Access Compliance Report

Public Rights-of-Way

(Curb Ramps)

Intersection ID: 48463	Main Street: PANGLEMONT_DR	Cross Street: CHANDLER_HAVEN_DR	Location: W
ADA ID: C1576C451717	Ramp Type: PerpDiag	Initial Pass/Fail: Fail	Overall Compliance: No
Severity Score: 33.75			
Codes/Mitigation Info/Possible Solution		Field Measurements/Component Compliance

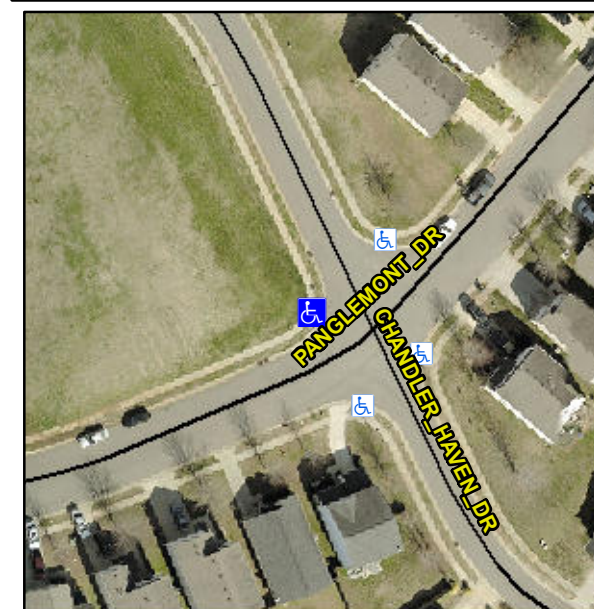
Not Found, R304.5.1, R304.2.2

Compliance	Description	Data	Compliance	Description	Data
N/A	Ramp Length (in)	48.0	No	Ramp Slope (%)	12.1
No	Ramp Width (in)	46.0	Yes	Ramp XSlope (%)	0.5
N/A	Flare Type LT	N/A	N/A	Flare Type RT	N/A
N/A	Flare Slope LT (%)	N/A	N/A	Flare Slope RT (%)	N/A
N/A	Flare Traversable LT?	N/A	N/A	Flare Traversable RT?	N/A
N/A	Landing Length (in)	N/A	N/A	DWS Provided?	N/A
N/A	Landing Width (in)	N/A	N/A	DWS Contrast?	N/A
N/A	Landing Slope (%)	N/A	N/A	DWS Length (in)	N/A
N/A	Landing X Slope (%)	N/A	N/A	DWS Full Width?	N/A
N/A	Landing Curb? (Y/N)	N/A	N/A	DWS Offset (in)	N/A
N/A	Shared Landing?	N/A			
N/A	Gutter Ponding?	N/A	N/A	Gutter Slope (%)	N/A
N/A	Gutter Lip Ht (in)	N/A	N/A	Gutter X Slope (%)	N/A
N/A	Painted X Walk1?	No	N/A	Painted X Walk2?	No
	X Walk 1 Direction	To S		X Walk 2 Direction	To NE
N/A	X Walk 1 Width (in)	N/A	N/A	X Walk 2 Width (in)	N/A
	X Walk 1 Slope (%)	0.1		X Walk 2 Slope (%)	0.2
	X Walk 1 X Slope (%)	0.3		X Walk 2 X Slope (%)	0.6

Remove & Replace Curb Ramp With Two New Directional Ramps or Equivalent.
